The 55 details drawn differently in CAD and Revit

Checked against the new drafters' file, 26 October.

55 of the 190 CAD typical details have a Revit version in your templates that is drawn differently. Each page: your CAD detail on the left, the Revit version on the right, what differs, and one answer: CAD is right, Revit is newer (we update CAD from it), or both wrong.

CAD: KOR-D504-DET 06 - DOWNTURN DETAIL

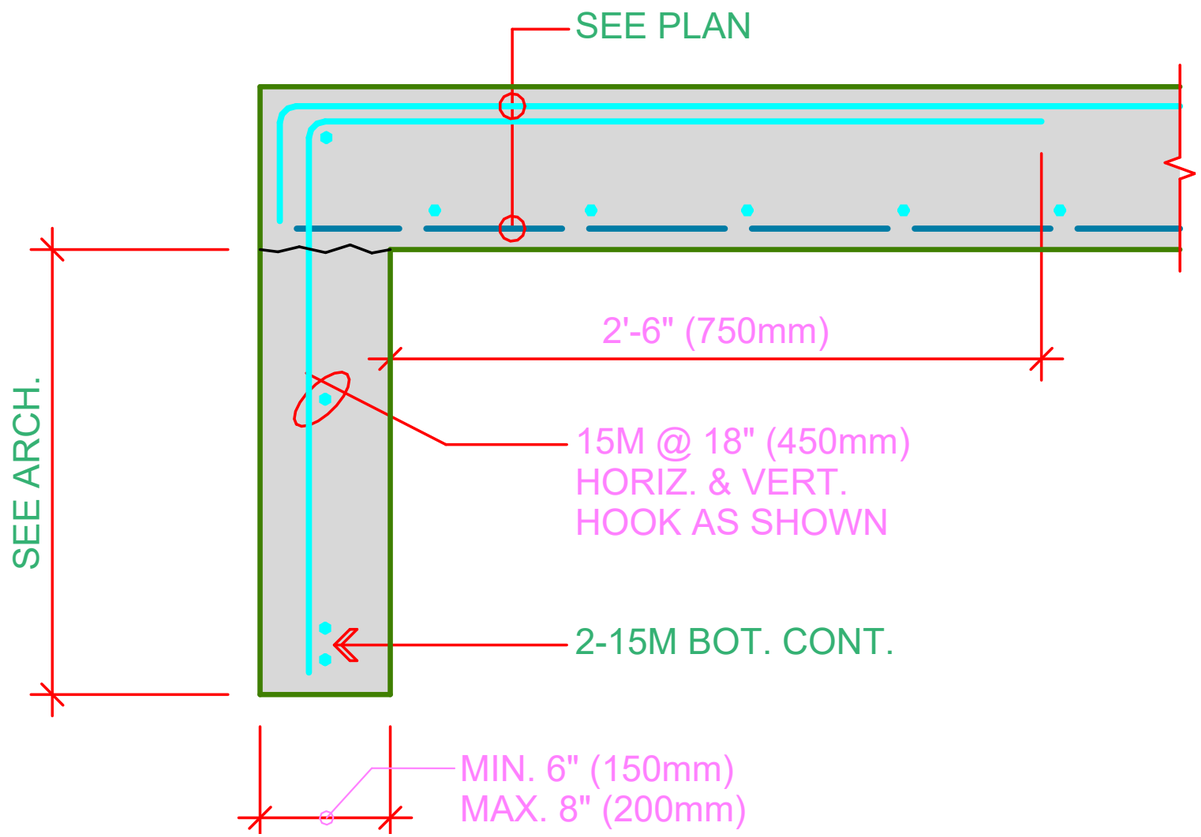
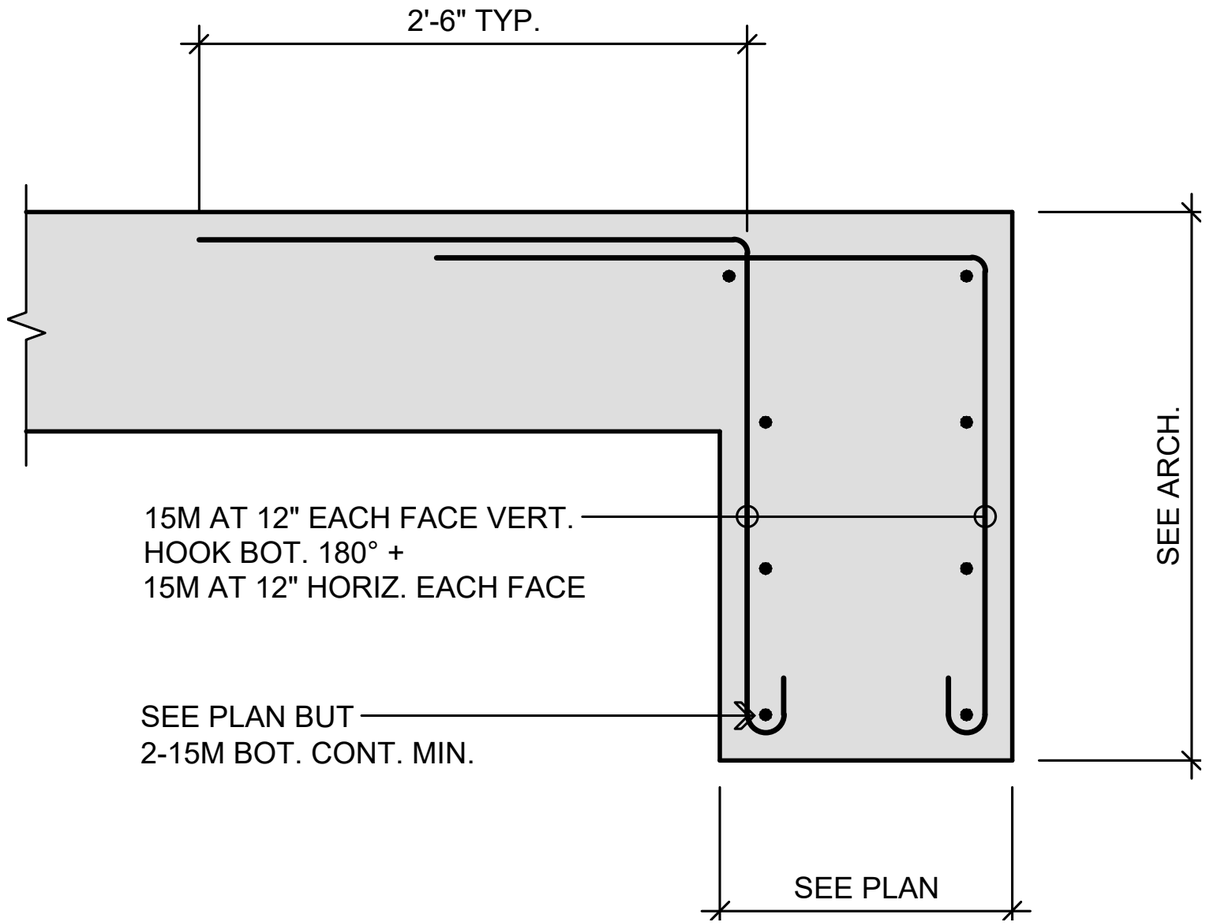
What differs: CAD is a 24in-min downturn beam with stirrups, 2-20M top and 4-25M bot projecting past an opening; '1E1.04_13_TYPICAL DOWNTURN' is a thin 6-8in downturn wall with 15M @ 18in.

CAD: KOR-D504-DET 07 - DOWNTURN DETAIL

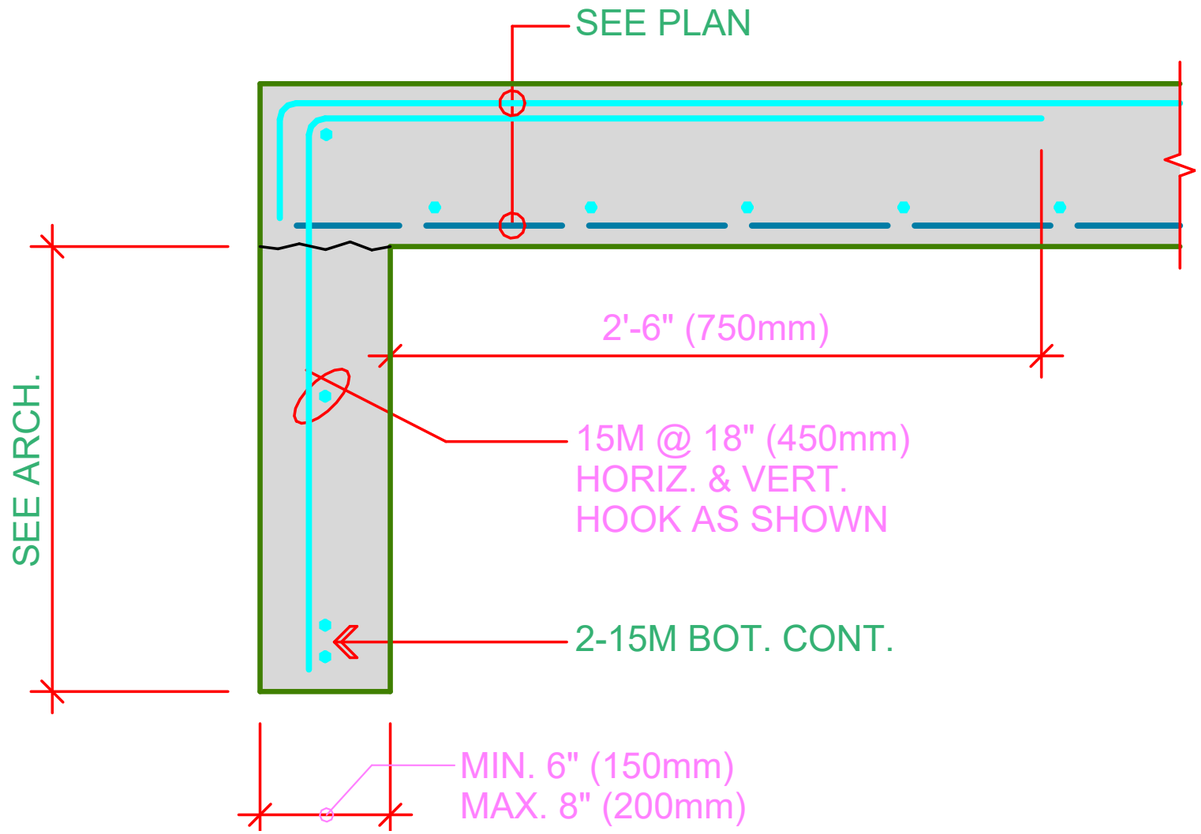
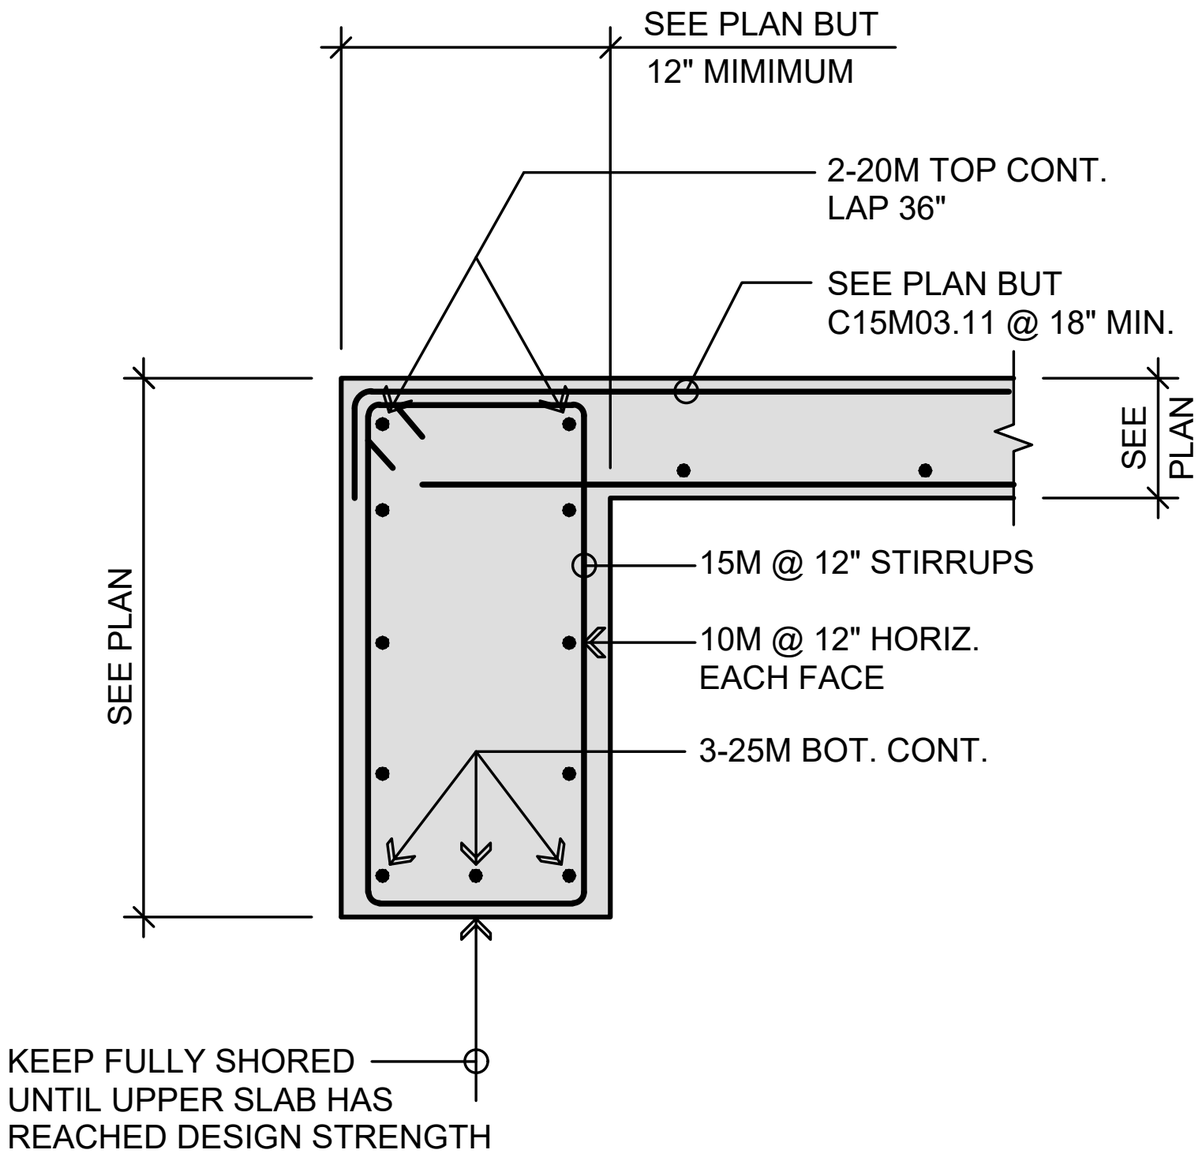
What differs: Same 2'-6in slab-edge downturn idea, but the CAD uses 15M @ 12in each face and a wider section; '1E1.04_13_TYPICAL DOWNTURN' uses 15M @ 18in.

CAD: KOR-D504-DET 08 - DOWNTURN DETAIL

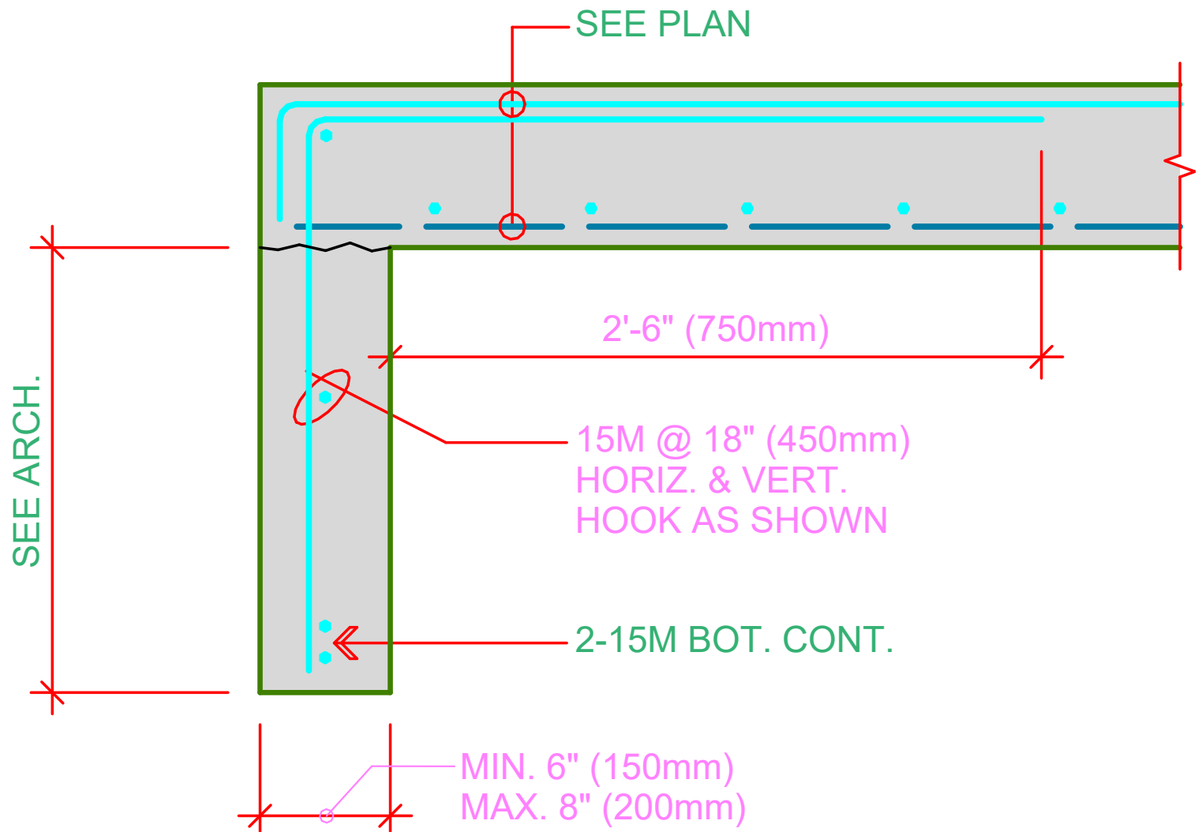
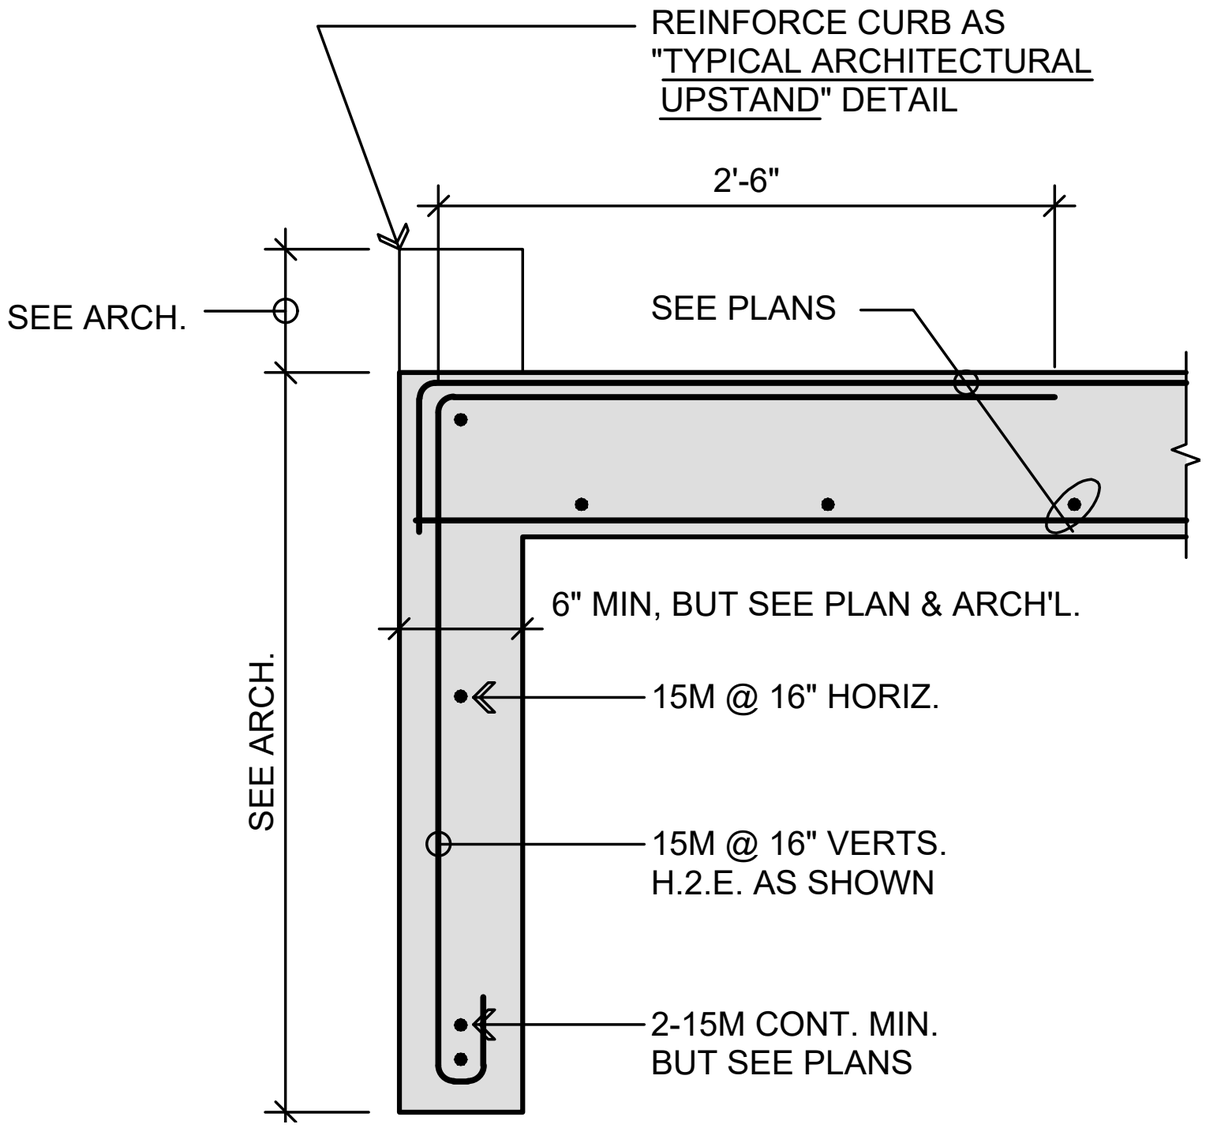
What differs: CAD is a stirruped downturn beam (3-25M bot, keep shored); '1E1.04_13_TYPICAL DOWNTURN' is a plain thin downturn wall.

CAD: KOR-D504-DET 09 - DOWNTURN DETAIL

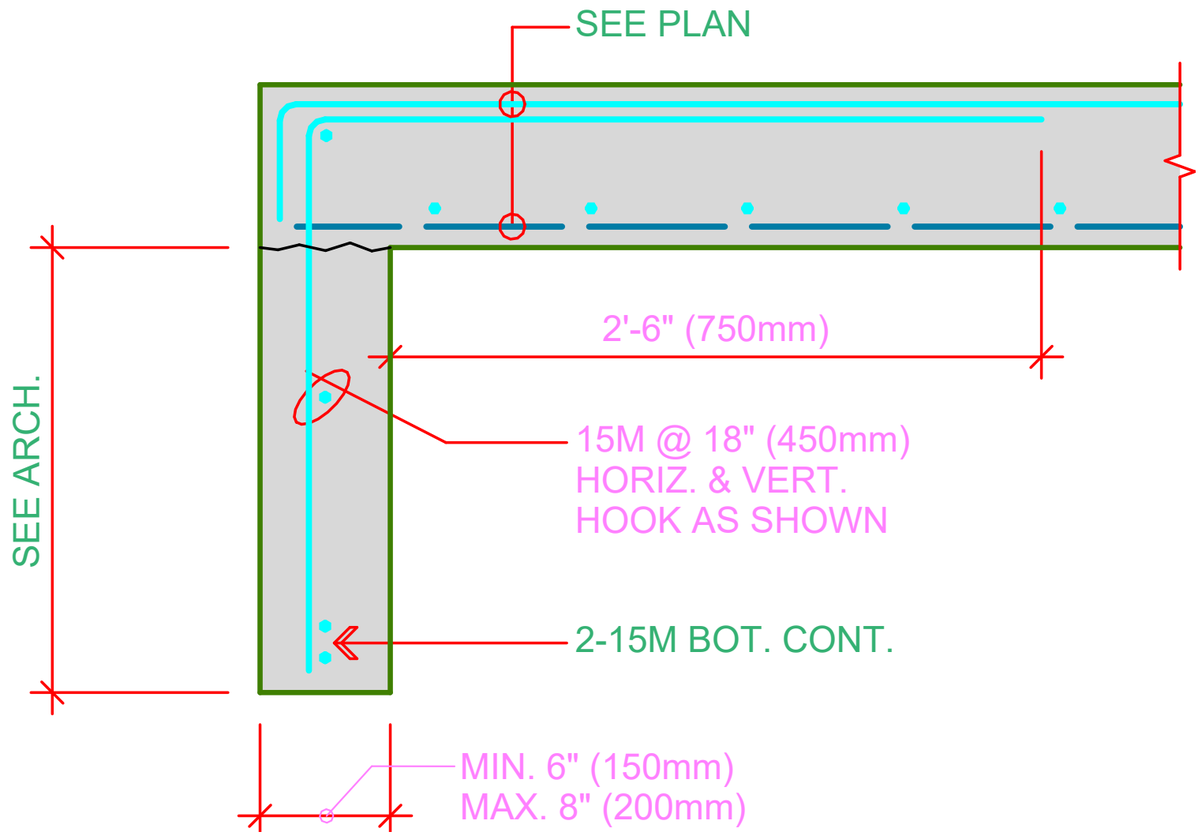
What differs: Closest match: same 2'-6in downturn with 2-15M bot cont, but the CAD has 15M @ 16in horiz/vert where '1E1.04_13_TYPICAL DOWNTURN' has 15M @ 18in, plus a curb/upstand callout.

CAD: KOR-D504-DET 10 - BALCONY DETAIL

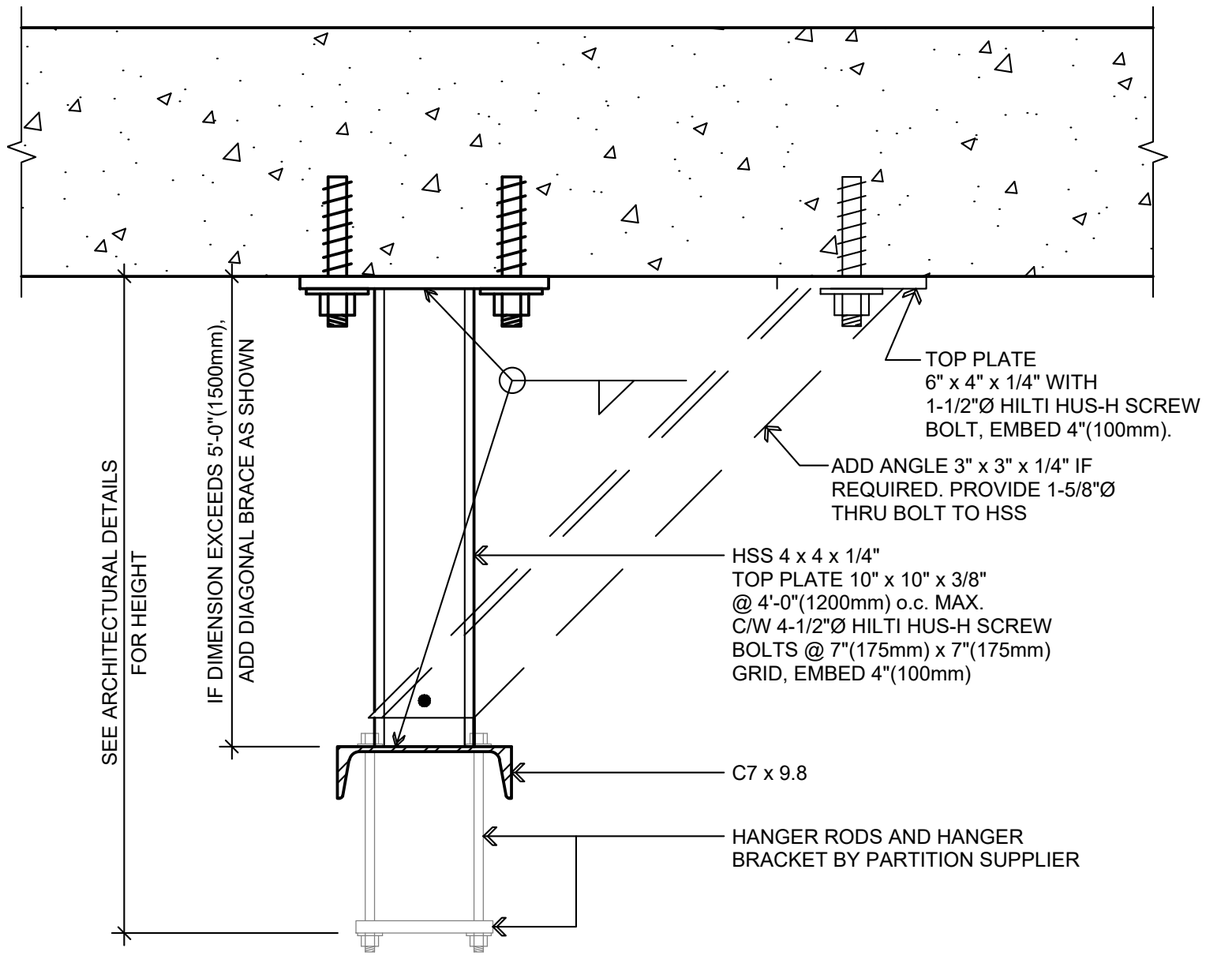
What differs: Both are balcony slabs thickened for drain slopes; the CAD has a 7 1/2in slab and 1 1/2in max thickening without the curb and guardrail hook-bar note '1E1.04_7_TYPICAL BALCONY DETAIL' shows.

CAD: KOR-D505-DET 03 - FOLDING PANEL HANGER DETAIL

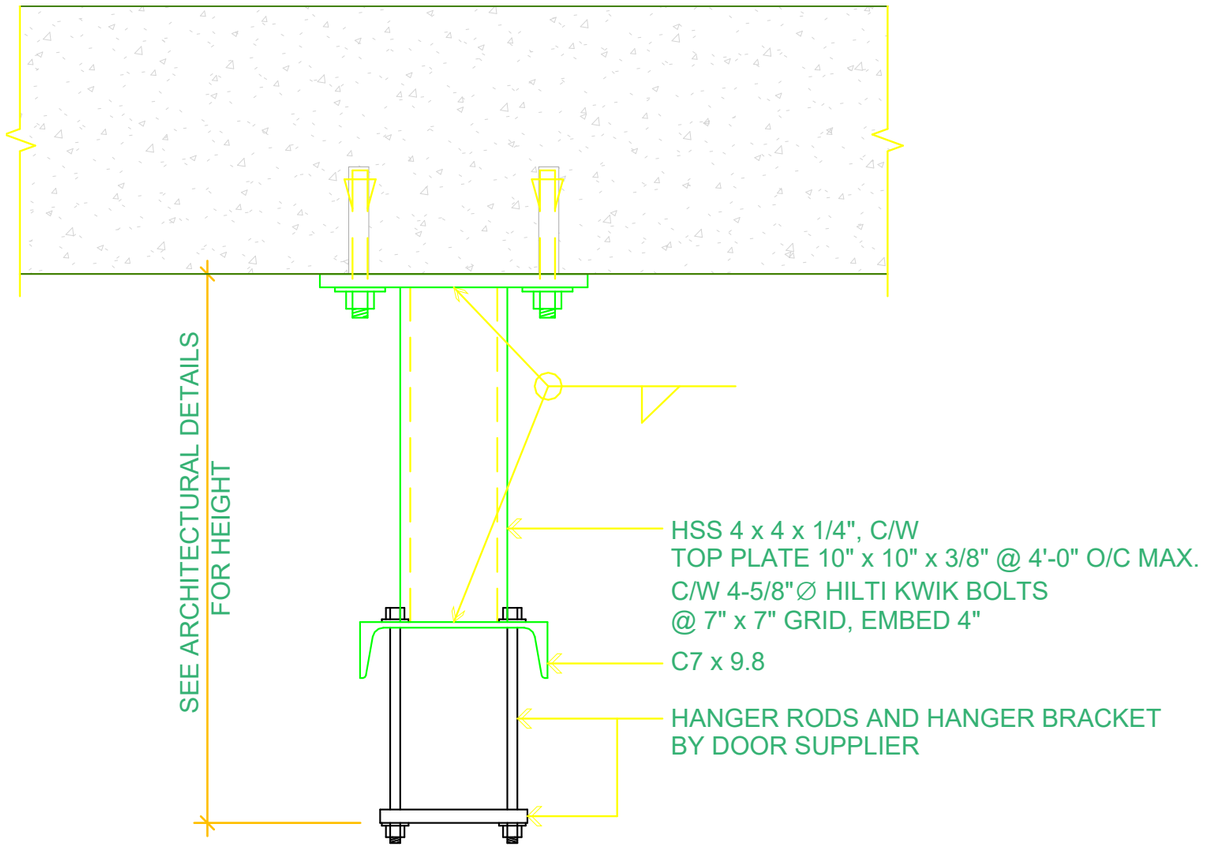
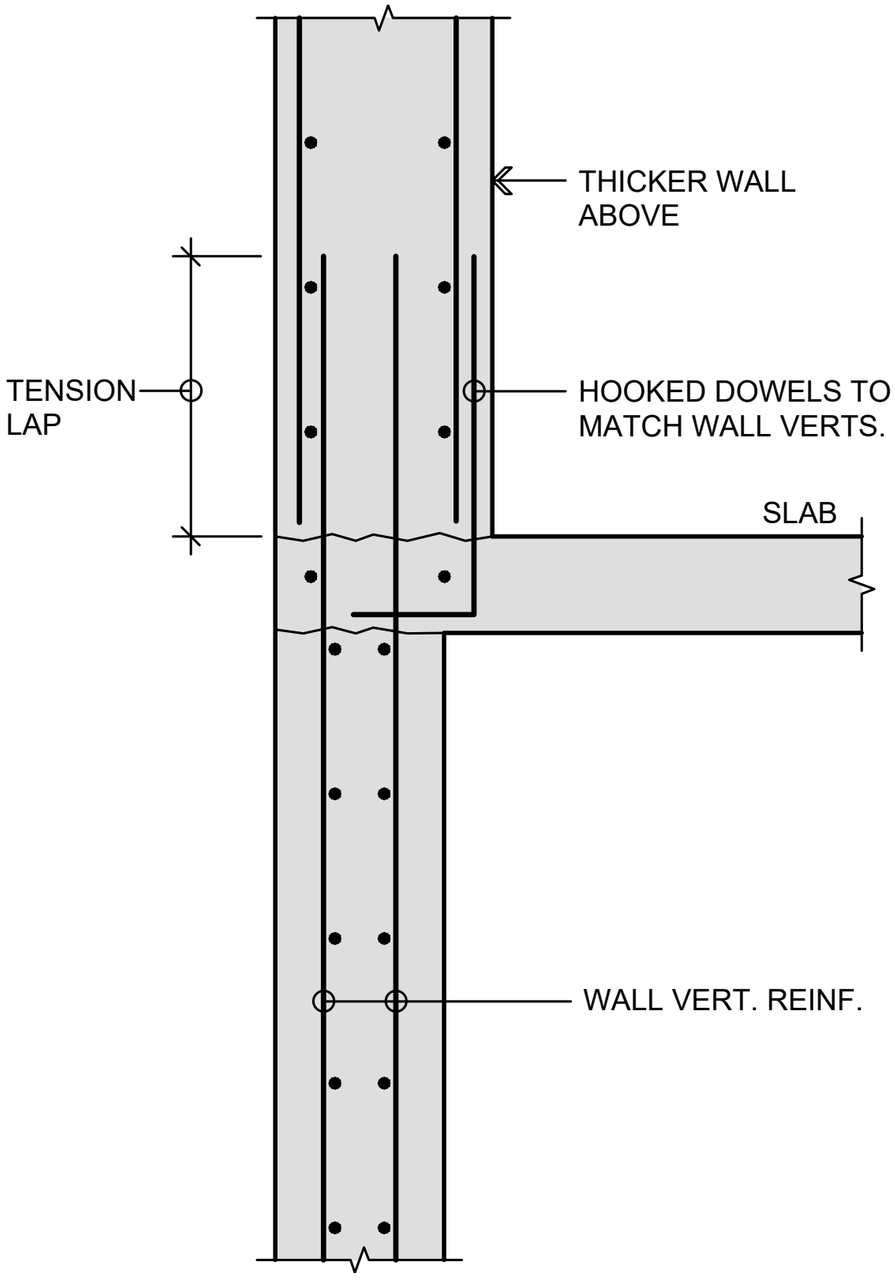
What differs: Same folding panel hanger, but the CAD adds a diagonal angle brace and uses Hilti HUS-H screws @ 6ft for a 15 psf door; 'D5.01_12_FOLDING PANEL HANGER DETAIL' has Kwik bolts @ 4ft for 20 psf and no brace.
